Chapter 7

Response to Comments

AVEP Solar Project
By Chaparral Solar, LLC and Rabbitbrush Solar, LLC

**Re: Response to Comments for Draft Environmental Impact Report – AVEP Solar Project by
Chaparral Solar, LLC and Rabbitbrush Solar, LLC (PP18141)**

Figure 3-4: EXISTING WILLOW SPRINGS SPECIFIC PLAN DESIGNATIONS

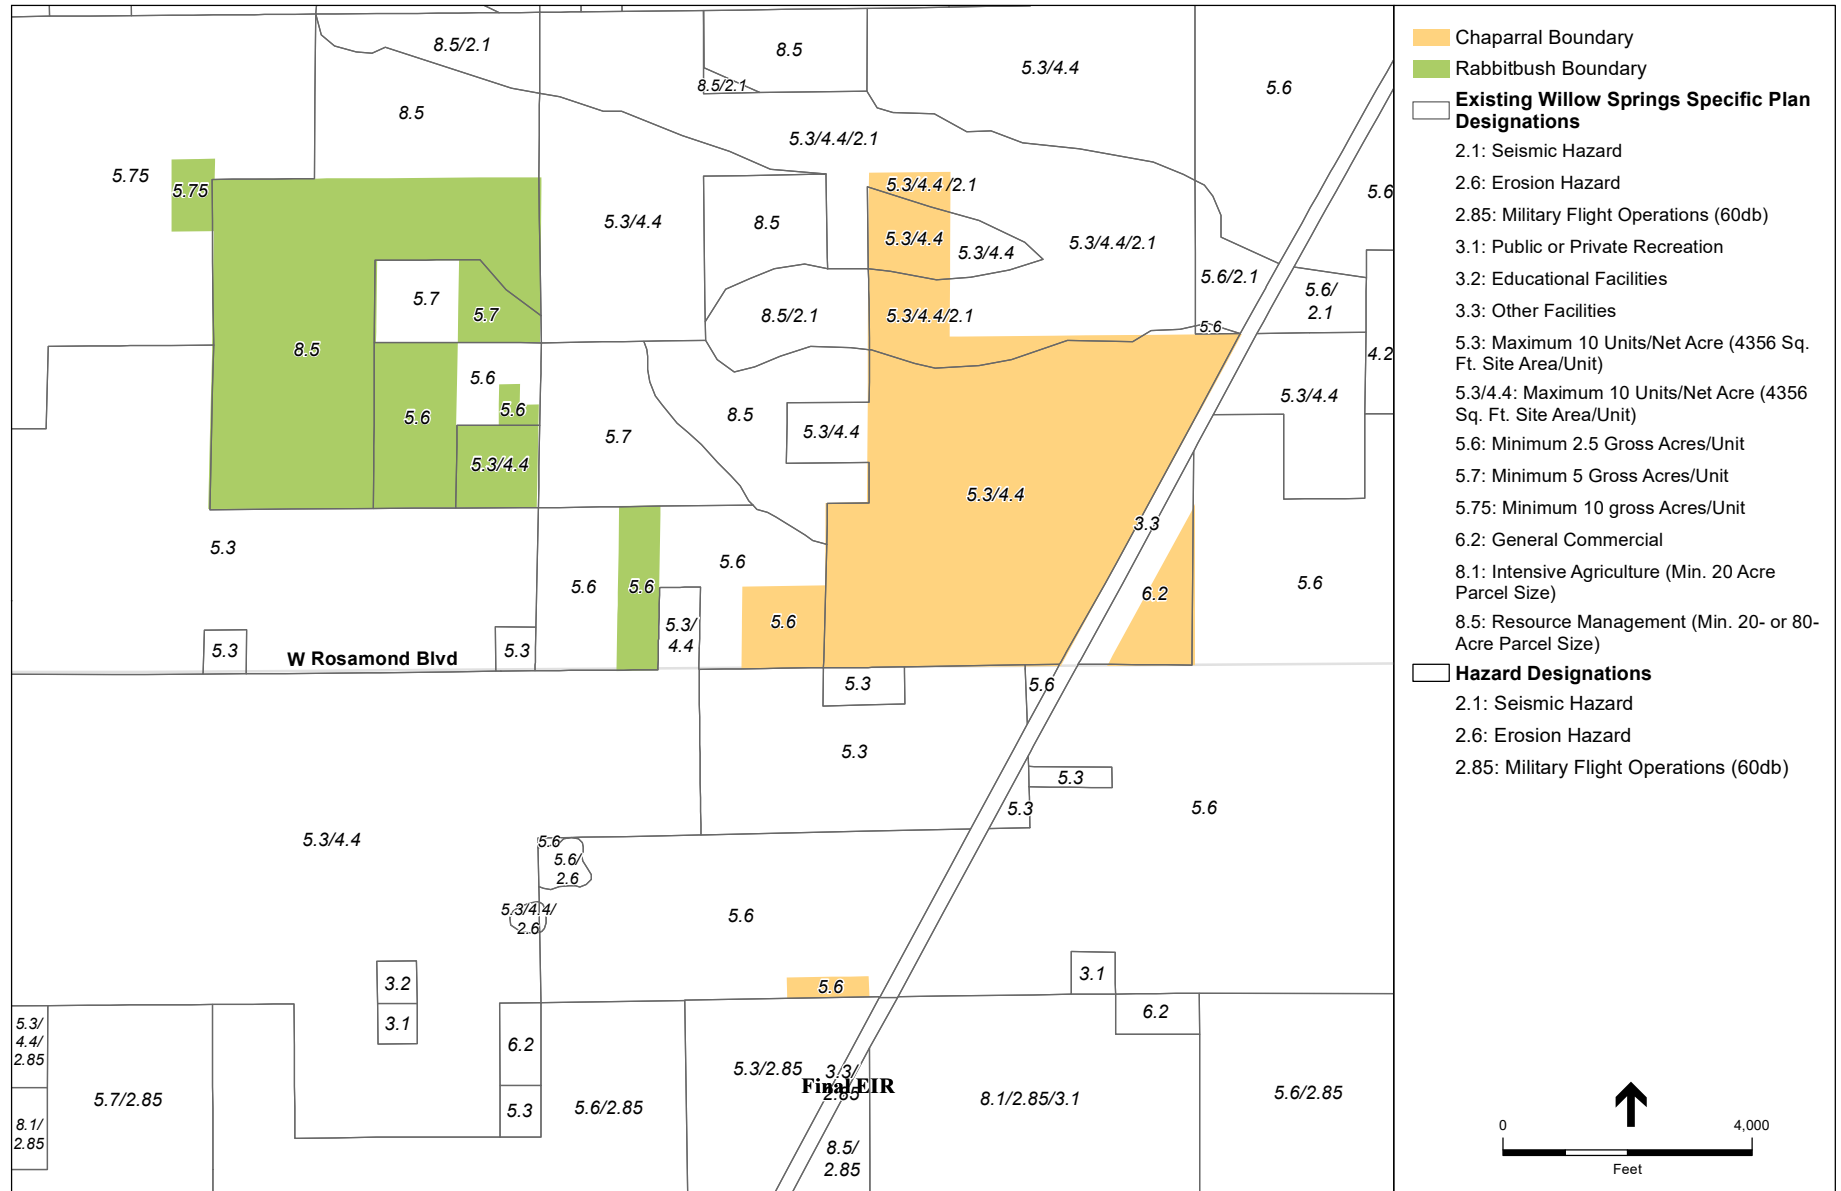
Figure 3-4, Existing Willow Springs Specific Plan Designation, has been revised to label the northernmost parcel of the Chaparral Site as Specific Plan Map Code Designation 5.3/4.4/2.1 instead of 5.3/4.4.
